APPLICATION NO.	FILING DATE	FIRST NAMED INVENTOR	ATTORNEY DOCKET NO.	CONFIRMATION NO.
09/787,398	03/16/2001	Werner Kruger	P01,0019	2420
29177	7590	11/08/2005	EXAMINER	
BELL, BOYD & LLOYD, LLC			CHIANG, JACK	
P. O. BOX 1135			ART UNIT	
CHICAGO, IL 60690-1135			PAPER NUMBER

**Advisory Action
Before the Filing of an Appeal Brief**

Application No.: 09/787,398
Reply to Office Action dated June 7, 2005

FIG. 1

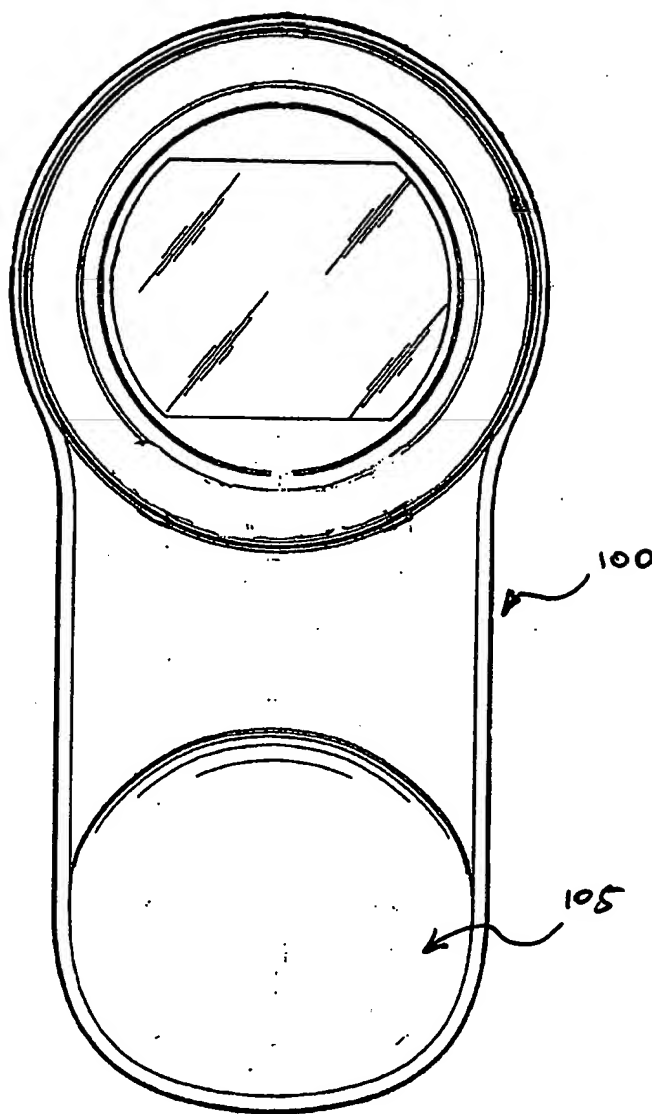
1. The amendments to the specification and the drawings filed 10/11/05 will not be entered for the following reasons. First, in the Brief Description of the Drawings, it states that Figs. 3-4 are exemplary embodiment(s). Noted that there is only one embodiment (figs. 1-2), but figs. 1-2 are in two different (open and closed) stages. It is unclear whether Figs. 3-4 intend to describe fig. 1 or fig. 2, because upper shell and lower shell are in different positions in fig. 1 and 2, it is difficult to see that fig. 4 itself can be used to achieve the functions in both figs. 1-2 according to all the functions described in the specification.

Not
Entered
J.

FIG 3

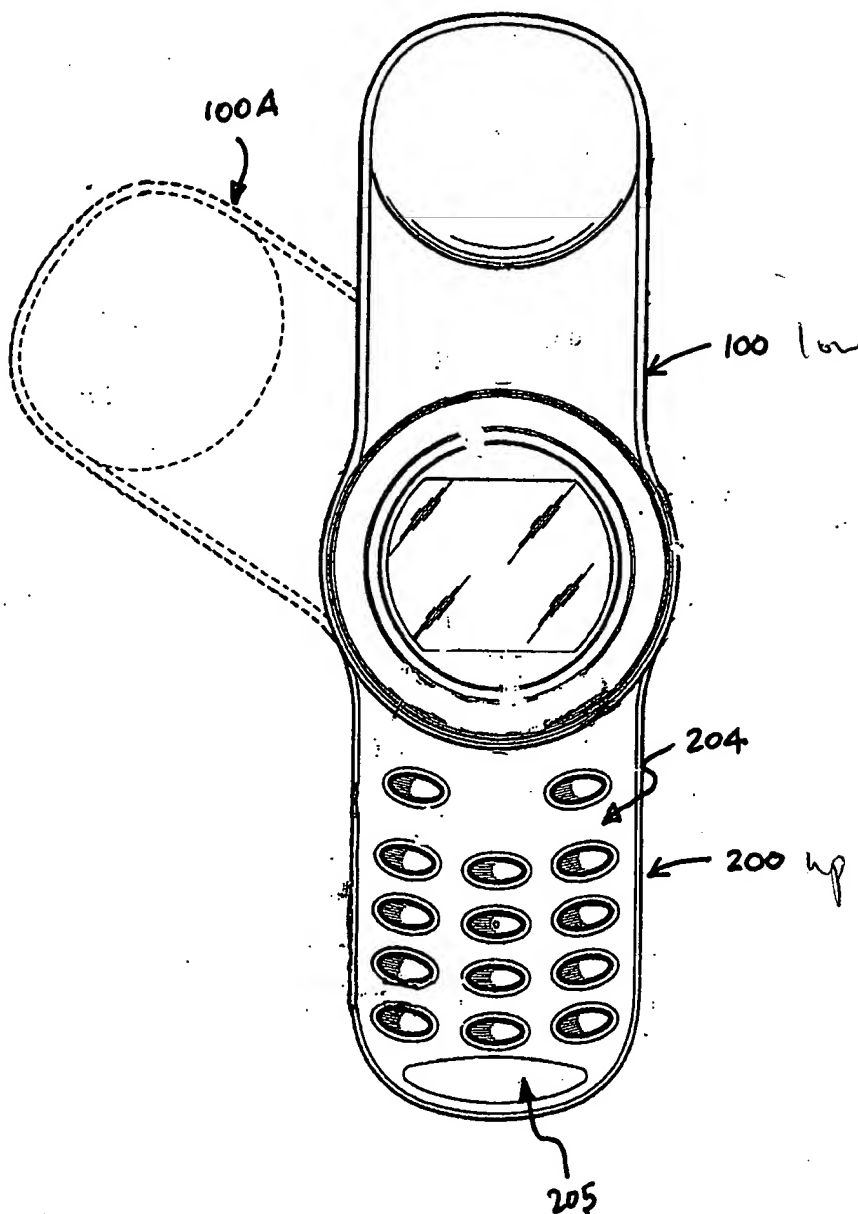
Further, in page 3, line 4, fig. 3, element (bus) 150, page 4, lines 9-10, first, it shows an electrical bus 150 connecting the upper and lower shells (100, 200), then it states that the upper shell 100 and lower shell 200 are not electrically connected to one another. In conclusion, the statements are contradicting each other and may be a new matter too.

NOT
Entered
in
the
file

FIG 4

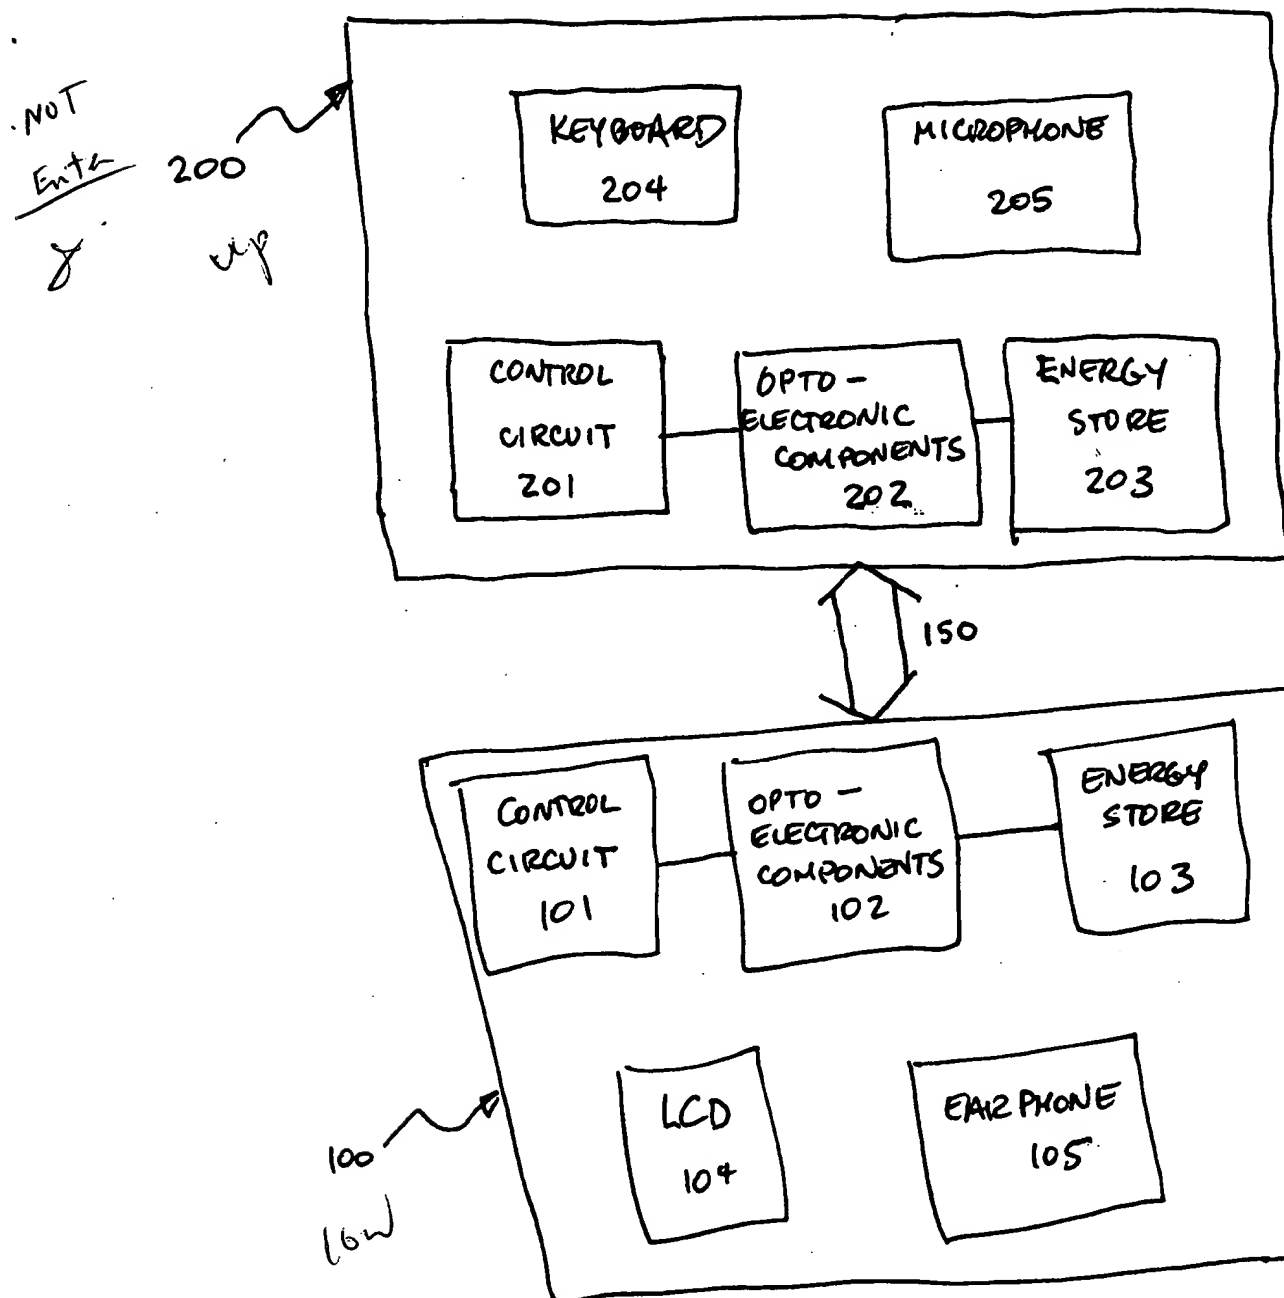
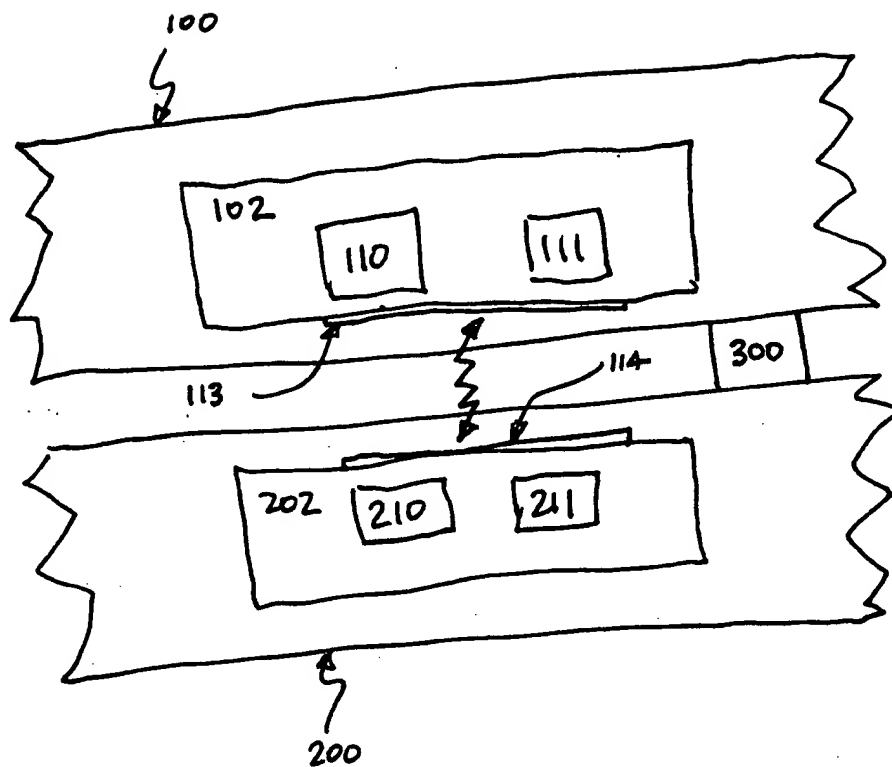
N.T
Enter
x
